**CONDITIONAL USE APPLICATION**

PROPERTY INFORMATION			
Project/Property Address: <b>Morse Road</b>		Project Name/Business Name: <b>Morse Road 14</b>	
Parcel #: <b>025-011219-00</b>	Zoning: (see <a href="#">Map</a> )	<b>MFRD</b>	Acreage: <b>13.96</b>

Re: Resubmission for Morse Road Multi-Family Development

Re: Resubmission for Morse Road Multi-Family Development

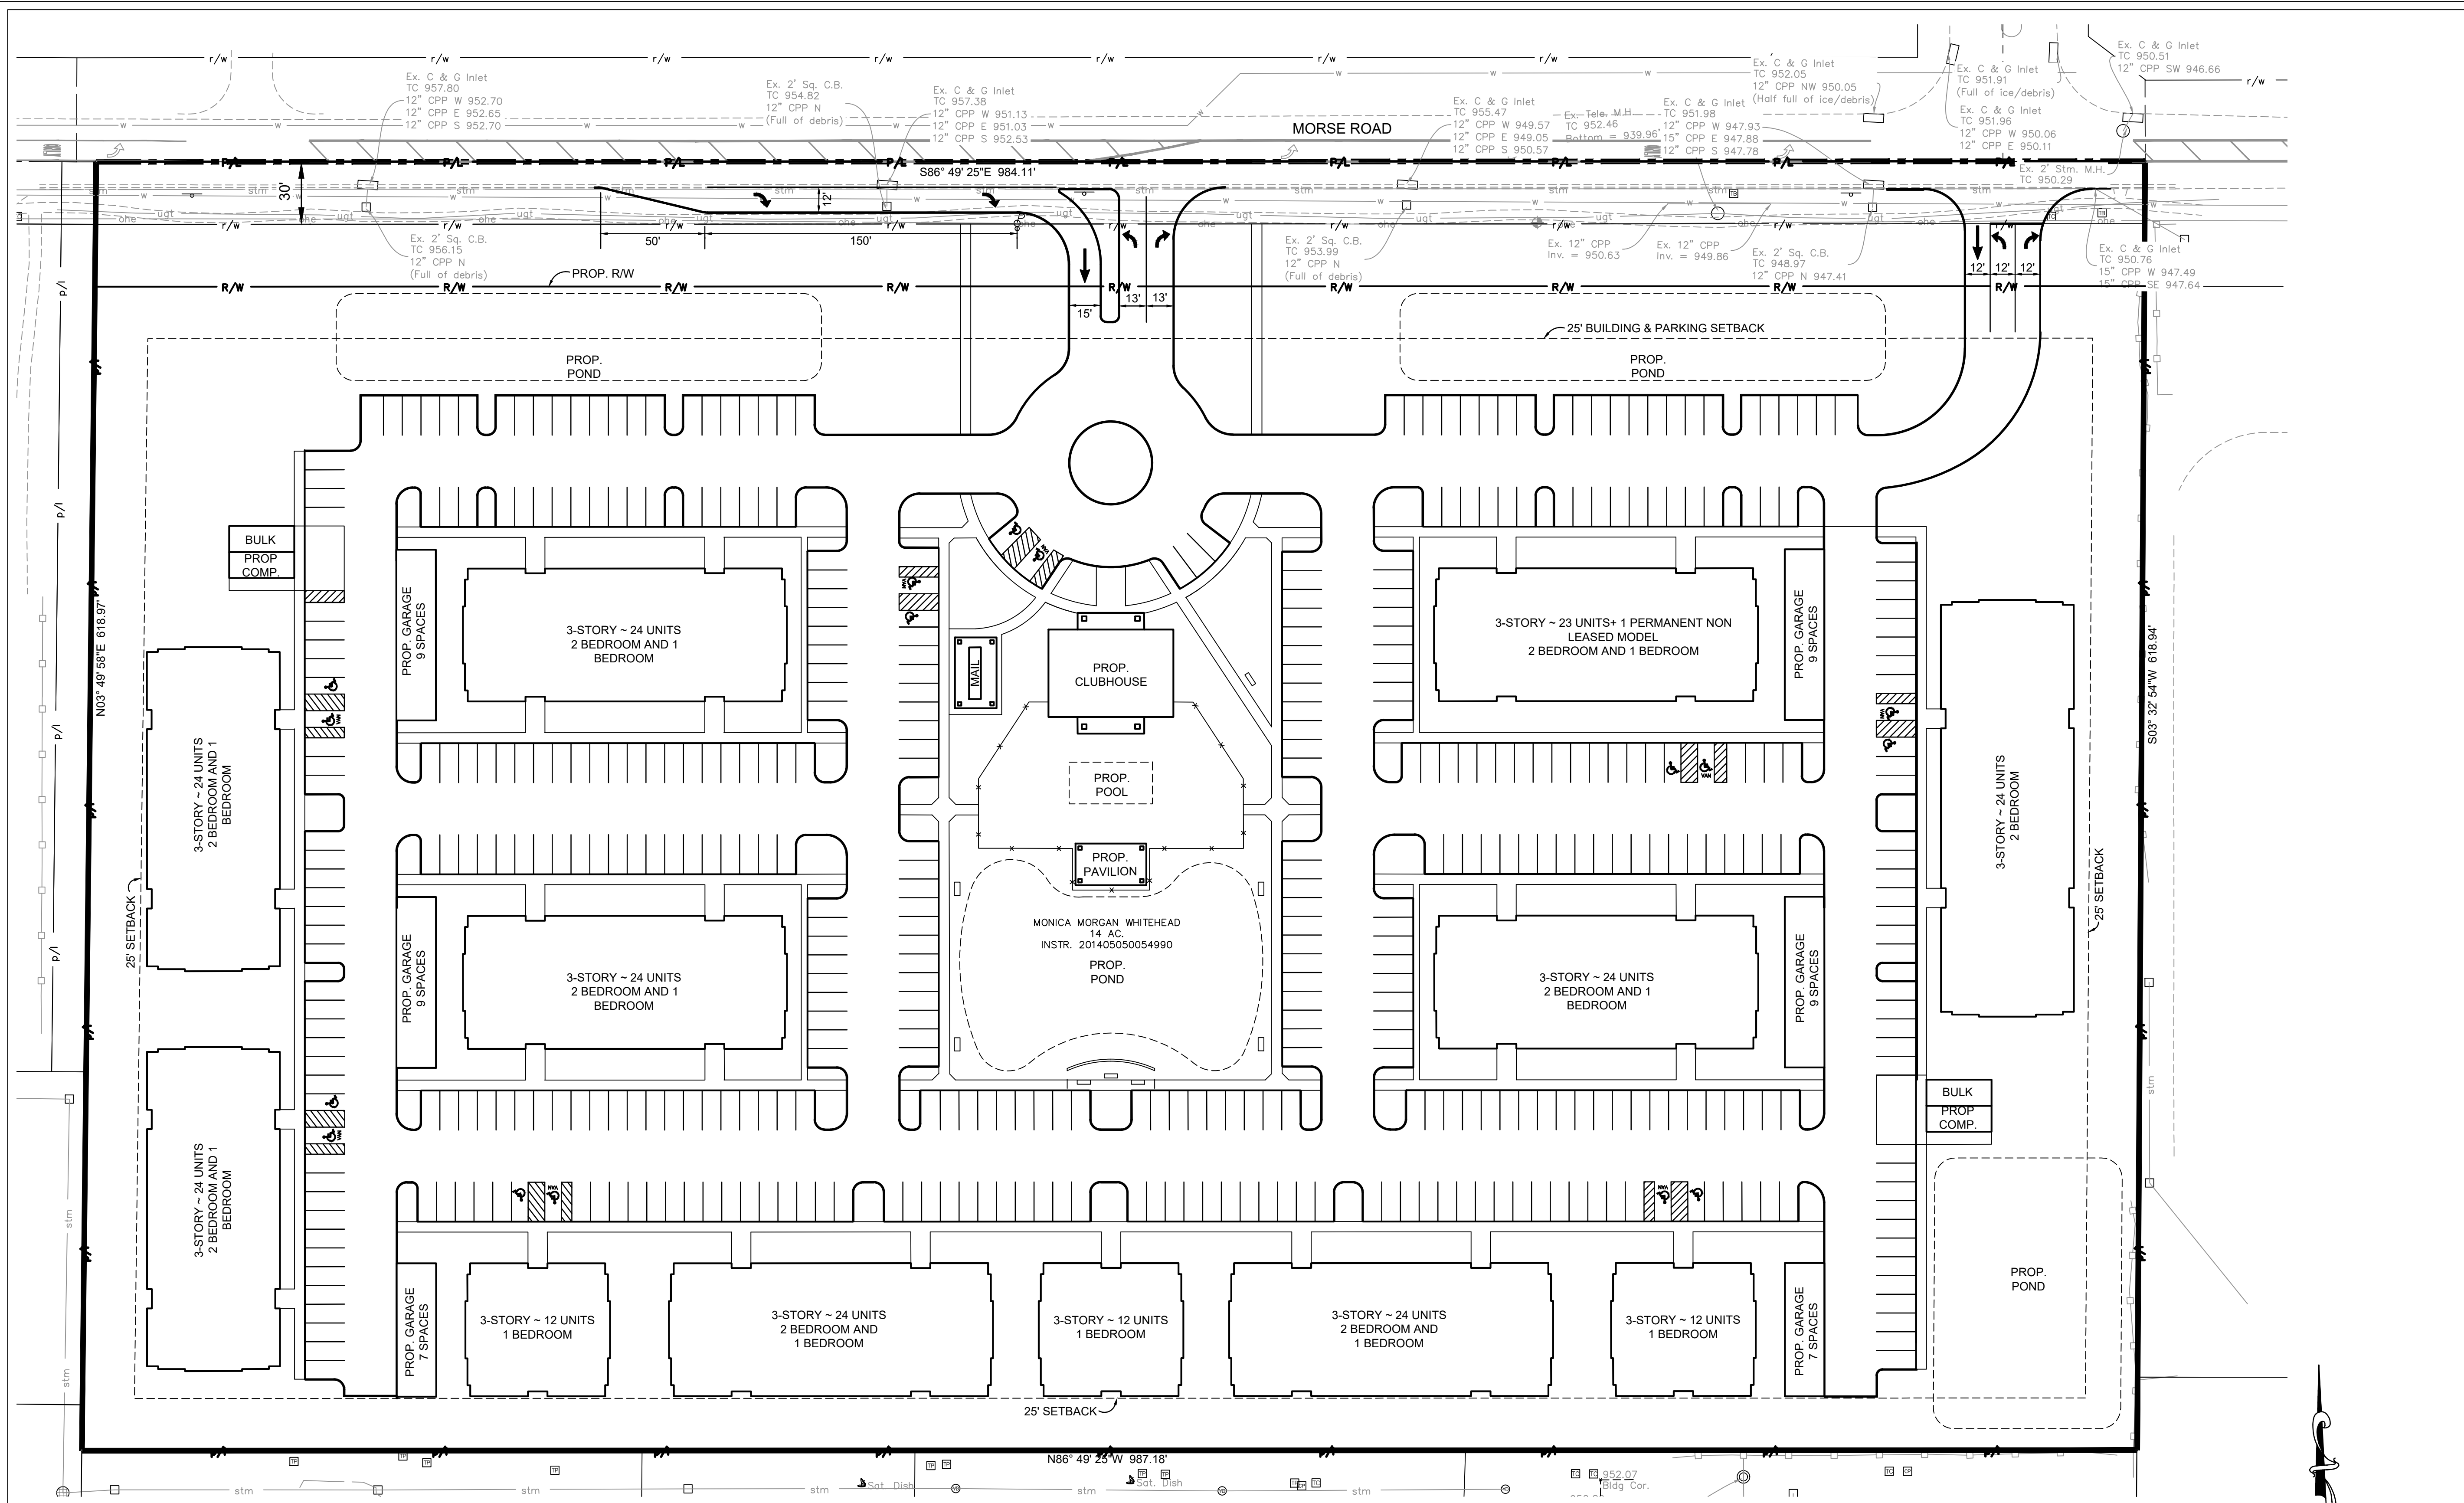
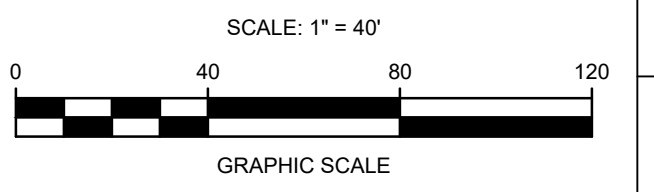
Please find herein our revised site plan and response to the City comments received on May 17th, 2022 related to the rezoning application for the property on Morse Road. We are submitting herein our response to the City comments for the Conditional Uses dated May 17th, 2022.

Our site plan has been revised to show a total of 251 units which is within the permitted density of 18 units per acre. Please note that the developer will have one non leasable permanent model that will be located close to the clubhouse and leasing office. Please disregard our previous site plan submissions and review only the attached site plan which is dated June 9, 2022.

The site plan has also been revised to respond to the engineering review regarding the required 60' dedication corridor along Morse Road. This is consistent with the City of Columbus Multimodal Thoroughfare Plan.
